Mathematical & Computer Modelling

Consultation on WPD's modification proposal 016

M&CM Response to Consultation on WPD's modification proposal 016

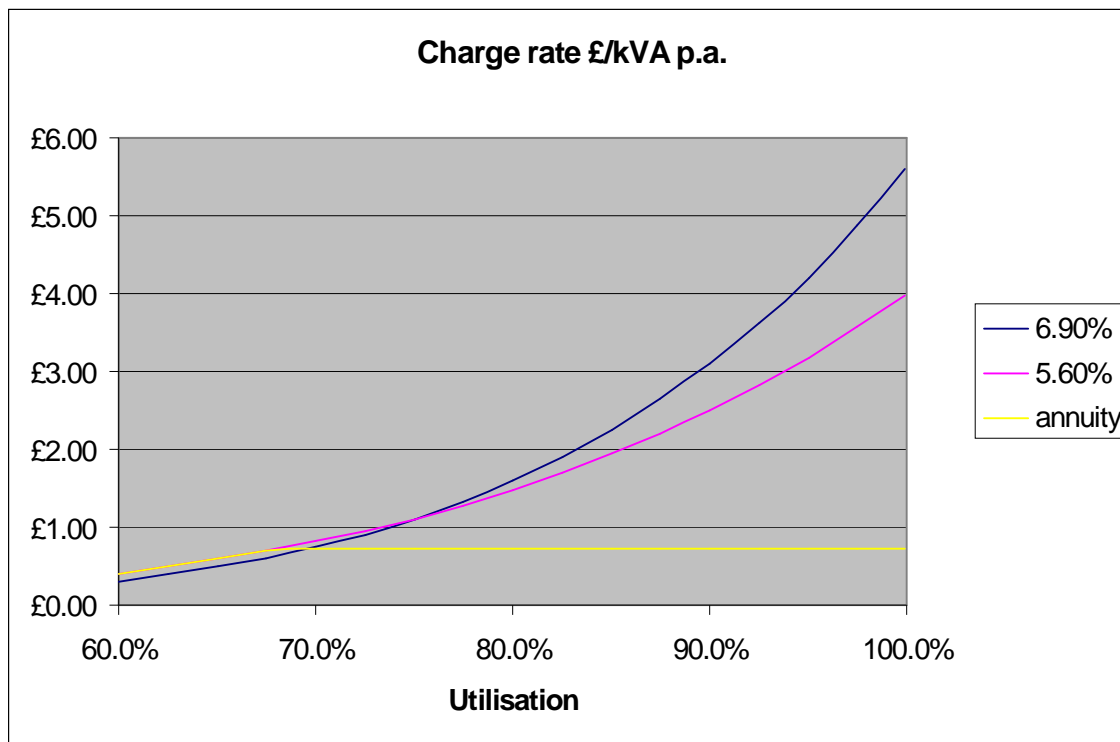
It is appropriate that the revised cost of capital should be used in setting charges as there would appear to be no basis for the continuing use of 6.9% p.a. The effect of using a lower rate of 5.6% is to reduce the charge rate at high utilisation but to increase the charge rate at lower utilisations. The chart on p7 of the consultation document appears to be incorrect. The following derivation and chart illustrate both these features:

Here the lower curve shows the minimum of the charge rate for an annuity over 40 years based on a cost of capital of 5.6% and the WPD LRIC charge rate based on 5.6%. The cross over between the two rates for the different costs of capital occurs at a utilisation of just below 70%.
